Item Name: Crosstube Assembly, Mid Fwd

DART AEROSPACE LTD HAWKESBURY, ONTARIO, CANADA	
DRAWING NO. D206-667-147	REV. A SHEET 1 OF 4
TITLE CROSSTUBE ASS'Y (206L MID FWD)	SCALE NTS

DRAWING NO. D206-667-147	TITLE CROSSTUBE ASS'Y (206L MID FWD)	REV. A	DART AEROSPACE LTD ENGINEERING ORDER		D.E.O. NO. D206-667-147-A-1	SHEET NO. SHEET 1 OF 1	SCALE NTS
DRAWN <i>qp</i>	CHECKED <i>AS</i>	MFG. APPR. <i>AS</i>	APPROVED <i>MD</i>		DE APPR. <i>MD</i>		
DATE 11.07.15	DATE 11.07.20	DATE 11.07.21	DATE 11.07.21		DATE 11.07.21

DRAWING NO. D206-667-147	TITLE CROSSTUBE ASS'Y (206L MID FWD)	REV. A	DART AEROSPACE LTD ENGINEERING ORDER	D.E.O. NO. D206-667-147-A-2	SHEET NO. SHEET 1 OF 1	SCALE NTS
DRAWN AJS	CHECKED [Signature]	MFG. APPR. [Signature]	APPROVED [Signature]	DE APPR. [Signature]		
DATE 12.08.02	DATE 12.08.02	DATE 12.08.02	DATE 12.08.02	DATE 12.08.02	DATE 12.08.02

DETAIL P
BONDING STRAP INSTALLATION 2 PL

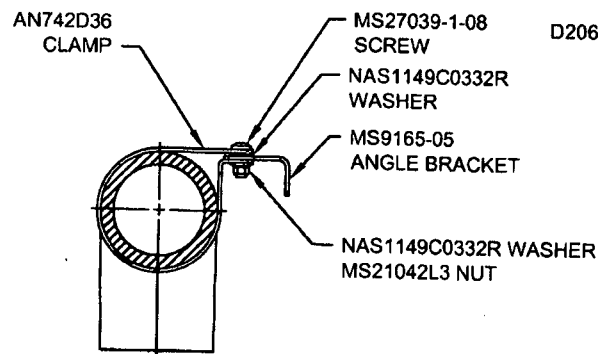
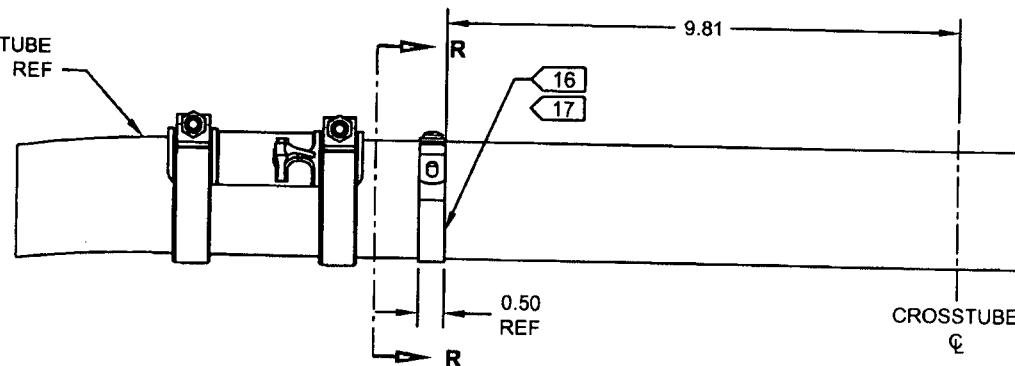
ADD ELECTRICAL GROUNDING STRAP

ITEM	QTY -147	PART NUMBER	DESCRIPTION
1	X	D206-667-147	CROSSTUBE ASSEMBLY (206L MID FWD)
10	2	AN742D36	CLAMP
11	2	MS9165-05	ANGLE BRACKET
12	2	MS21042L3	NUT (OR MS21042-3)
13	2	MS27039-1-08	SCREW
14	4	NAS1149C0332R	WASHER (OR AN960C10L)

- 16) MASK AREA UNDER CLAMP PRIOR TO PAINTING
 - 17) SEAL EDGES WHERE AN742D36 CLAMP MEETS WITH THE CROSSTUBE USING SIKAFLEX-241/-291 OR MIL-S-8802 CLASS B2 OR PROSEAL 890 SEALANT
 - 18) PERFORM RESISTANCE CHECK TO ENSURE MAX RESISTANCE IS 10 MILLIOHMS
- AFT
